MEMORANDUM

JN 10-107225

Subject: Old Mammoth Place – Visual Simulation Peer Review

Figure 6: View 4 Alignment

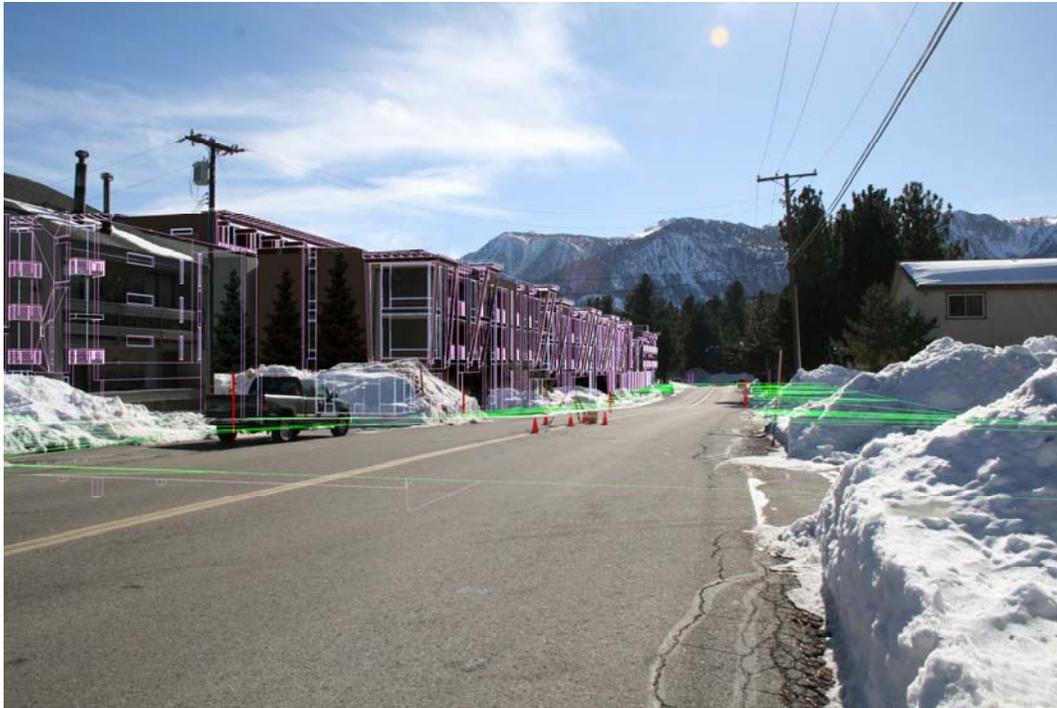
4. The RBF Model was imported into Electric Image Animation System to check the alignment of the photographs to the rendered exhibits. At this point the existing ground plane was modeled and included as an image tilt check. Figures 3 through 6 show the photographs using alignment data with existing reference points (i.e., signs, poles, etc.) and the wireframe overlay. As shown in these view simulations, the applicant's plans are accurately represented.

Figure 7: Site Plan View

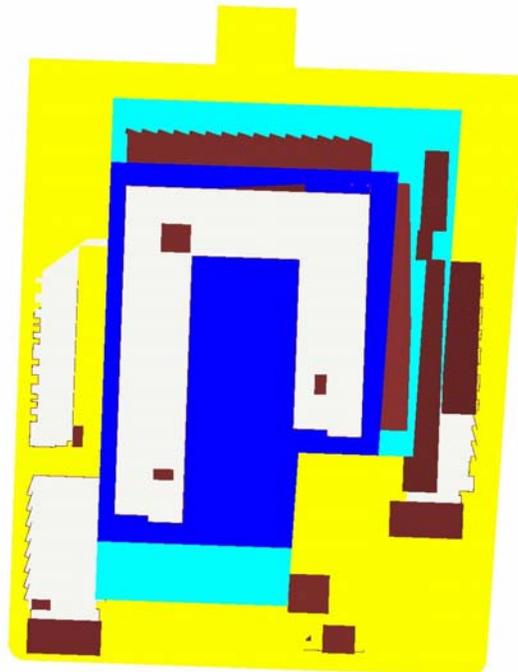
3. The building envelopes were penetrated by the building in height and parameter as illustrated by Figures 7 through 9 below.

Figure 10: Site Plan

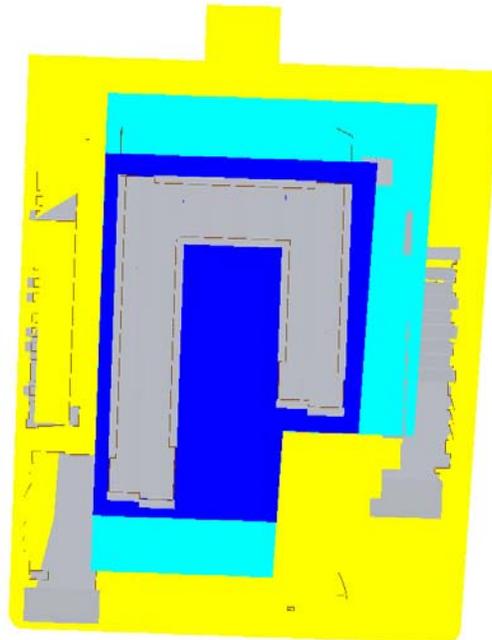
The following outlines the results of the evaluation of the views taking into account the Zone Code Amendment outlined above. The methodology used to evaluate the views is the same as that outlined previously under “RBF Evaluation Criteria”. However, Step 2 was modified to take into account the modified requirements from where the building heights should be measured from (i.e., podium level or average grade using the outermost corners of any distinct building mass). Figures 10 through 12 reflect the proposed project with the building envelopes measured per the Specific Plan Amendment specifications outlined above.

Although portions of the roof protrude from the building envelope, these exceedances are accommodated by the proposed adjustment in building height of 10 percent (3.5 feet) for up to 28 percent of the three-story buildings along Old Mammoth Road and six percent of the buildings fronting Laurel Mountain Road (specifically at the southernmost portion). As previously stated, the proposed areas of adjustment include the sloped shed portions that are situated within the 35-foot height zones within the Specific Plan. The maximum exceedance would be 3.42 feet along Old Mammoth Road. In the east elevation (Figure 12), height exceedances illustrated in dark brown are attributable to parapets, vertical surfaces of buildings, and elevator or stairway overruns. It should be also be noted that southern portion of the hotel building includes parapets that exceed the height limit by up to two feet, which is permitted by Section 5.2.6 of the Clearwater Specific Plan allowing for appurtenances to extend two feet above the allowable building height.
